NYISO MMU EVALUATION OF THE LONG ISLAND OFFSHORE WIND EXPORT PPTP REPORT

Market Monitoring Unit
for the New York ISO

May 2023

Figure 1: NPV of Benefits and Costs

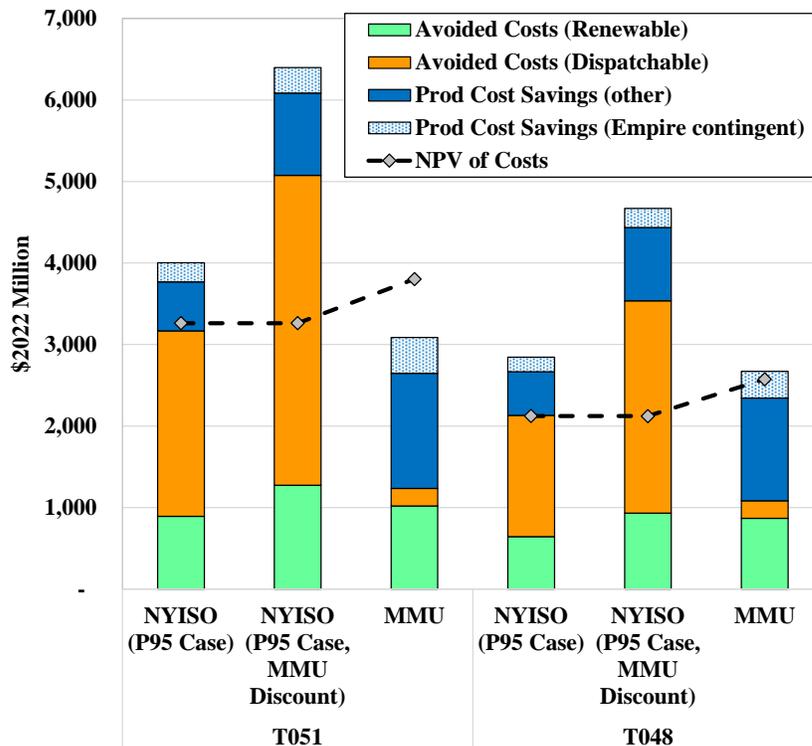
Based on our recalculation of both benefits and costs, Figure 1 compares the benefits and costs of the projects based on the NYISO assessment and our MMU assessment. Our assessment shows that the combined benefits for the T051 project are substantially less than the costs, yielding a Benefit-Cost Ratio of 0.81 over the 20-year period from 2030 to 2049. “NYISO (P95 Case)” implies higher overall benefits and lower costs. The estimate labeled “NYISO (P95 Case, MMU Discount)” shows that the benefits would be higher if they were appropriately discounted

Taken together, the lower benefits and higher costs in our assessment of the projects accounts for the reduction in the B-C Ratio for T051 of 34 percent. Figure 1 also shows our estimate of the overall Benefit-Cost Ratio of 1.04 for project T048. Our estimated B-C Ratio is higher for T048 (than for T051) because it has much lower capital costs, but only slightly lower benefits. In contrast, the NYISO evaluation of benefits would result in a lower B-C Ratio for T048 than for T051 primarily because it estimates higher avoided costs for dispatchable generating capacity investment for T051 than for T048. Overall, in consideration of the recalculated quantitative metrics, we find that T048 appears to be a more cost-effective project than T051.

Figure 2: Annual Benefits and Costs

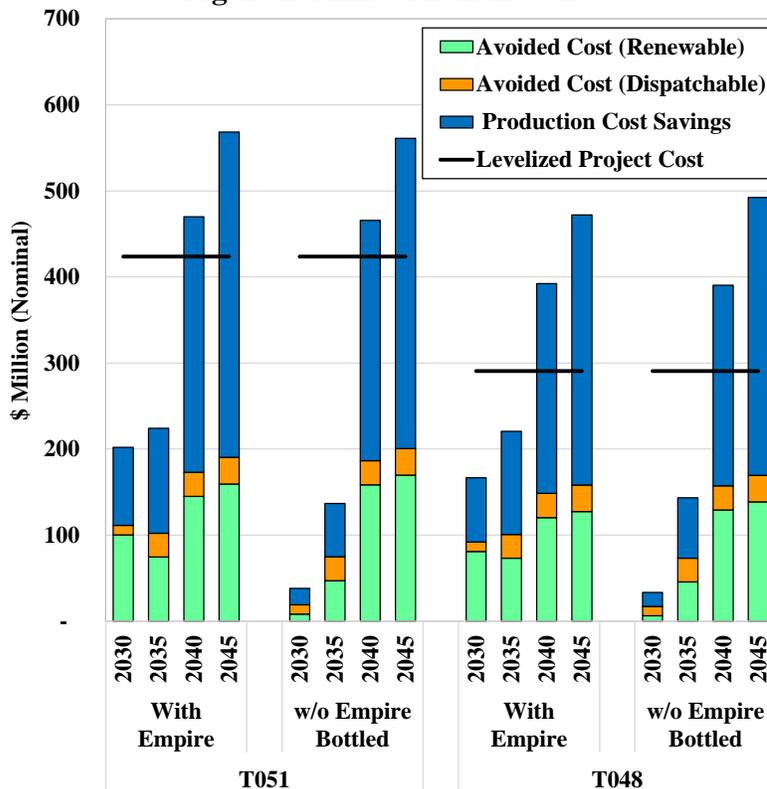
The benefits of new transmission vary considerably during the study period, so Figure 2 shows annualized costs and benefits amortized over the first 20 years of investment in 2030, 2035, 2040, and 2045. This is provided for T051 and T048 both with and without the Empire Wind II generator at its proposed point of interconnection. This highlights several key findings. First, the annual benefits from the projects would be very low relative to the annualized costs in 2030 and 2035. The production cost savings rise sharply in 2040 for reasons that we discuss below.

Second, most of the benefits in 2030 are contingent on the status of the Empire Wind II generator. If Empire Wind II does not proceed with construction, builds its own upgrade to become deliverable, or simply moves to a less constrained point of interconnection, most of the benefits would be lost in the initial years of the study period. This highlights the substantial uncertainty associated with these early benefits.

Third, our estimated benefits rise significantly over time making both projects appear cost-effective by 2040 when the State would become much more reliant on Dispatchable Emission Free Resources (“DEFER”). This occurs because DEFERs are assumed to have a relatively high marginal cost (\$150 per MWh) compared to conventional resources. Therefore, every MWh of avoided offshore wind curtailment saves \$150 per MWh in 2040 when DEFERs are assumed to be on the margin. This benefit is extremely uncertain because some zero carbon technologies are likely to be developed that have much lower marginal costs, such as small modular nuclear reactors. A mix of resources could be developed (e.g., carbon capture for conventional resources or green hydrogen technology) with a range of fixed and variable costs. To the extent that the future resource mix relies more on lower variable cost resources, the estimated production cost savings would fall sharply and the B-C Ratio for both projects would likely be less than 1.0 over the entire study period.

Figure 3: Implied Net REC Cost

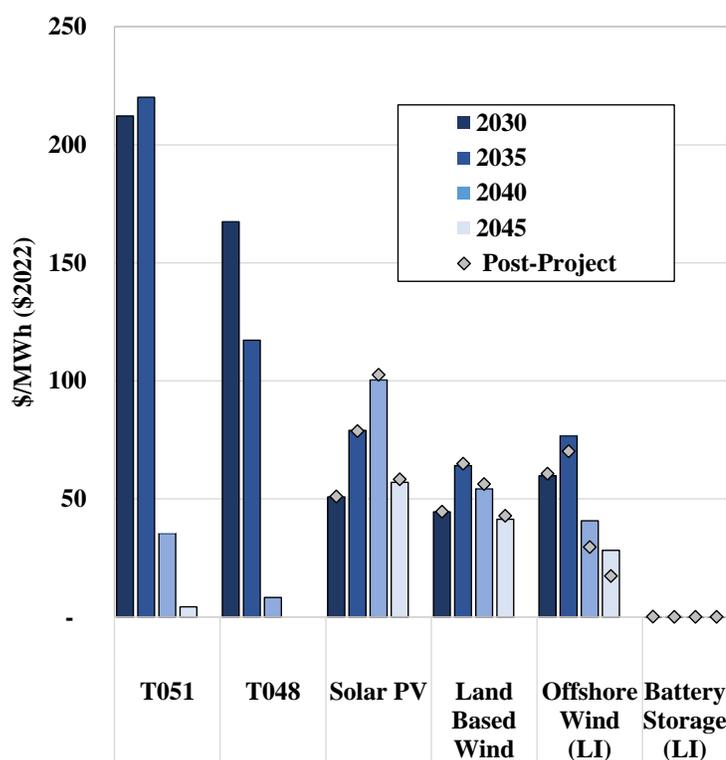
Second, the costs of increasing output from renewables by investing in T051 or T048 are significantly higher than the cost of investments in additional renewable resources or battery storage in 2030 and 2035. The transmission projects become more cost-effective by 2040 because of the sharp increase in production cost savings caused by reliance on DEFERs, thereby reducing the INREC Cost of transmission.

Third, the INREC Cost of battery storage is less than zero during the study period, indicating that investments in battery storage would be cost-effective even without any compensation for increasing renewable production by reducing their curtailment. This suggests that the NYISO modeled inefficiently low levels of battery storage penetration and that a substantial amount of additional battery storage could be used to reduce offshore wind curtailments on Long Island at a much lower cost than building transmission. However, additional simulations would be needed to determine how much more battery storage penetration would have been cost-effective.

Fourth, the proposed transmission projects have no effect on INREC Cost of generic offshore wind on Long Island in 2030, and only a relatively small effect from 2035 through 2045. This indicates that they would provide only modest benefits in facilitating additional offshore wind.

Figure 4: MMU Estimated Annual Benefits and Costs of T051 Project

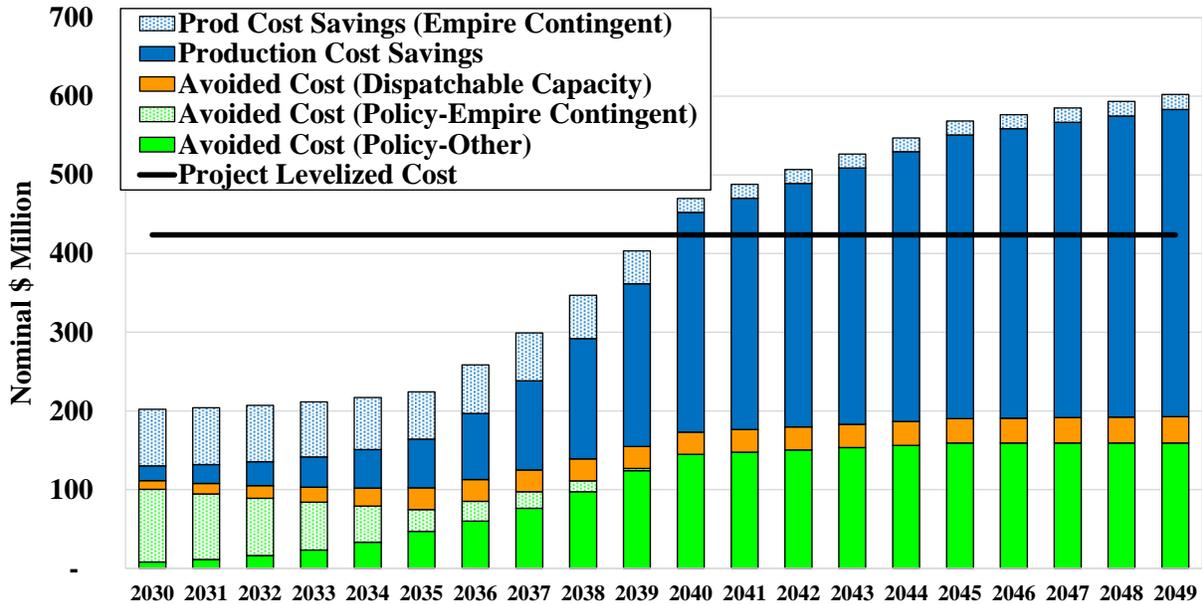
Figure 4 and Figure 5 show our estimated benefits and costs for projects T051 and T048 over the 20-year evaluation period. Project costs are shown on a levelized basis. Overall, we estimate

that T051 would produce benefits significantly below its costs until the late 2030s, when benefits would begin to exceed costs. On the other hand, we estimate that T048 would begin to produce benefits consistent with its costs two years earlier.

Figure 5: MMU Estimated Annual Benefits and Costs of T048

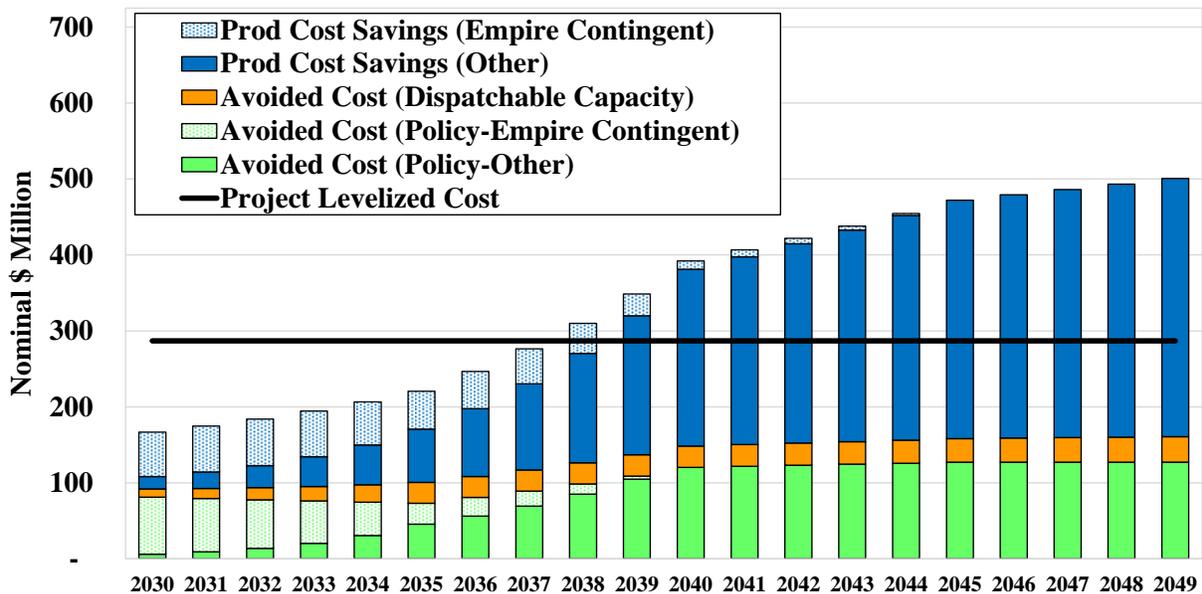
Production cost savings are the largest source of long-term benefits for both projects. For the first five years of the evaluation period, these would be expected to be come mainly from reducing curtailment of the planned Empire Wind II offshore wind facility by reducing

Figure 6: Impact of Projects on Curtailment of Offshore Wind and Other Renewables

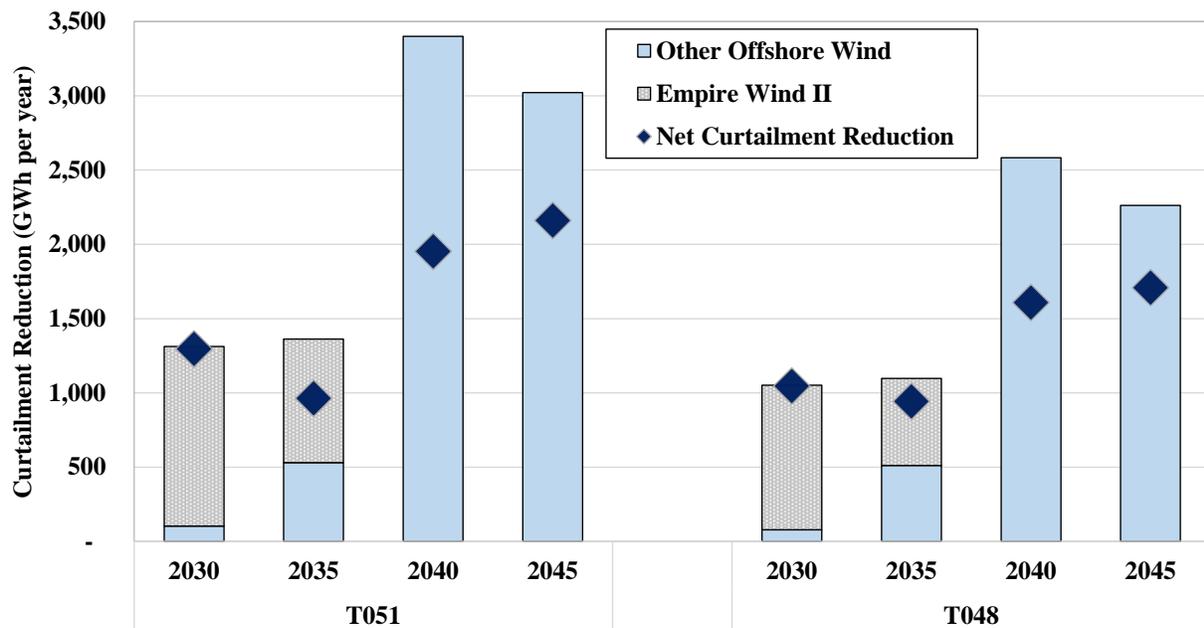
In NYISO’s 2030 and 2035 cases, the vast majority of offshore wind energy unbottled by T051 results from relieving congestion on the Barrett-Valley Stream facility limiting output from Empire Wind II, instead of from expanding Long Island’s export capability. T051 partially resolves the constraint affecting Empire Wind II, which experiences 46 to 49 percent curtailment in the pre-project case and 19 to 21 percent curtailment in the project case. In 2040 and beyond, T051 is expected to eliminate more curtailment because of the assumed deployment of 6 GW of offshore wind on Long Island. T048 exhibits somewhat smaller impacts on curtailment of offshore wind over the study period.

Beginning in 2035, the offshore wind unbottled by the T051 project causes curtailment of other renewable resources (including wind, solar and hydro) in other parts of the state. Approximately one-third of the offshore wind unbottled after 2035 causes curtailment of other renewable resources.¹⁴ We use this ‘net’ impact on curtailment to calculate the Implied Net REC of the proposed projects below.

Figure 7: Implied Net REC Cost of T051, T048, and Generic Investments

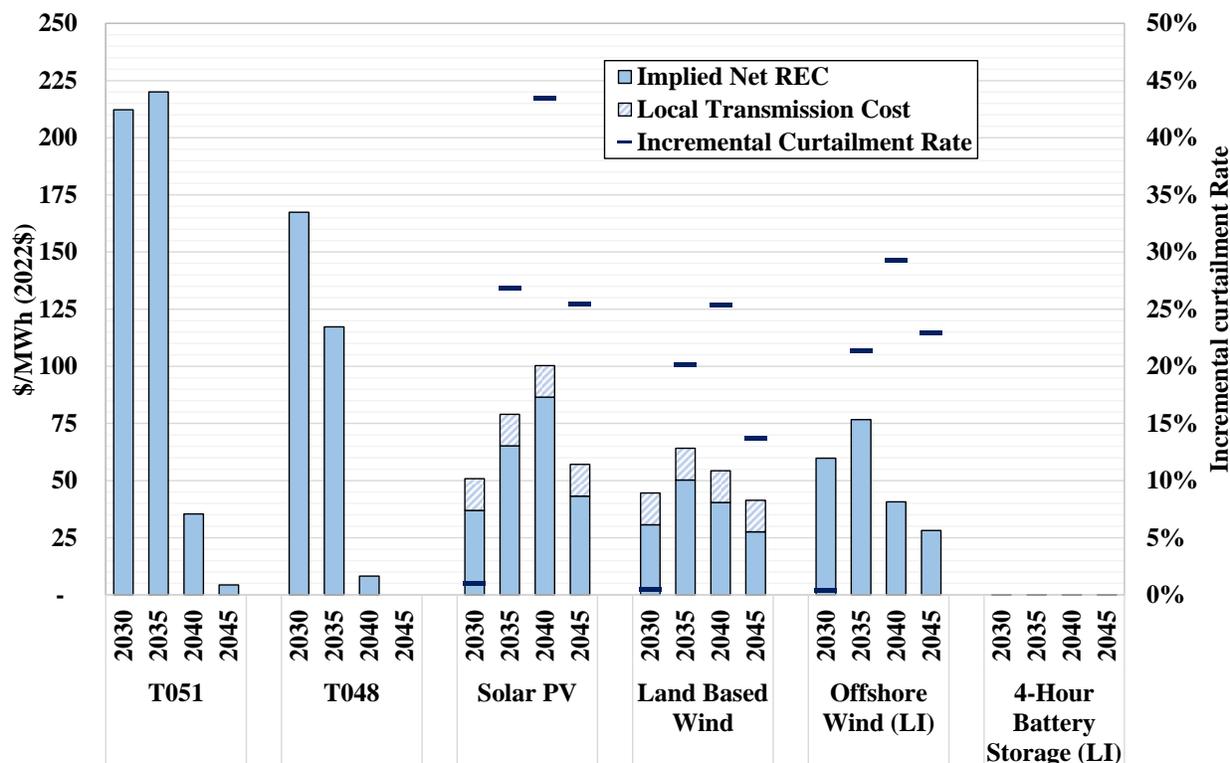
Figure 7 compares the estimated INREC Cost of the T051 and T048 projects over the evaluation period to alternative investments in renewables.¹⁵ The T051 and T048 INREC Costs are estimated using the benefits and net curtailment reductions discussed above. The INREC Costs of renewables and storage are estimated using NYISO’s policy base case, which does not include the proposed transmission projects.¹⁶ NYISO did not model local transmission constraints in upstate regions that would impact energy deliverability and revenues of renewables there, so we include in the renewable INREC cost the estimated cost of local transmission upgrades based on

The INREC cost of T051 is initially very high (~\$212 per MWh in \$2022 in 2030) because it has low expected economic benefits relative to its costs during that period. This indicates that T051 is a very costly means to increase the supply of renewable energy during this period compared to investing in additional renewable capacity, even after accounting for partial curtailment of the renewables. The INREC Cost of T048 is significantly lower but remains higher than other technologies until around 2038. In 2040 and beyond, the INREC cost of the proposed transmission projects falls rapidly because it is projected to provide much greater production cost benefits (reducing its net cost) and reduce more offshore wind curtailment. This suggests that

T051 would not be a cost-effective way to increase the supply of RECs (compared to investing in additional renewable capacity) until 2040.

Figure 8: Illustration of Upstream Transmission Constraints

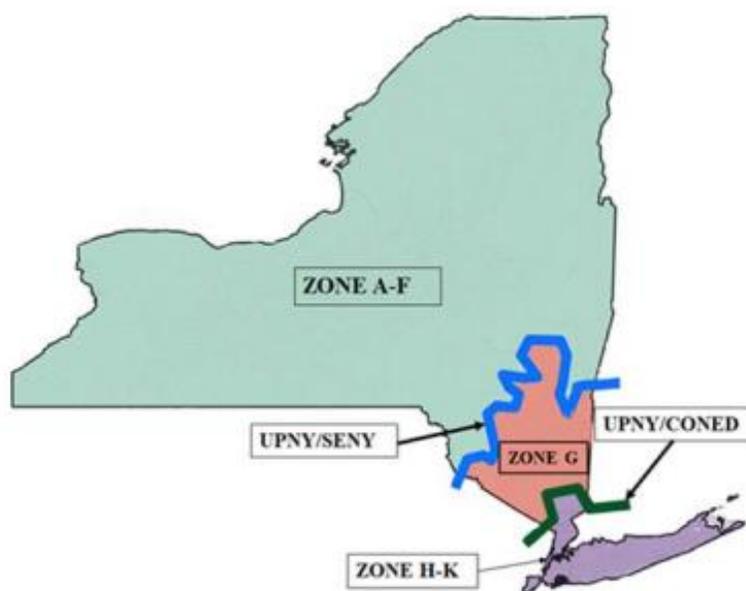
NYISO assumed without any analysis that the LCR in Long Island will fall by the same amount as the reduction in its TSL-based requirement. This ignores the fact that the LCR Optimizer considers many other transmission constraints that may limit flows between the upstate region and Long Island. If upstream bottlenecks restrict the ability of additional upstate capacity to serve downstate New York, an increase in the transfer limit to Long Island from other downstate areas will not allow more capacity to be held upstate unless those upstream constraints are also upgraded.²⁵ Figure 8 below shows a simplified representation of the location of key constraints impacting flows between upstate and downstate New York.

These constraints include the UPNY-CONED constraint (between zones G and H) and the UPNY-SENY constraint (between zones A through F and zone G). The proposed transmission projects would increase transfer capability between Long Island and other zones within the H-K group, but none of them would increase transfer capability across UPNY-CONED or UPNY-SENY interfaces. However, (though NYISO did capture these interface limits in the capacity expansion and production cost models) the NYISO did not use its resource adequacy model to
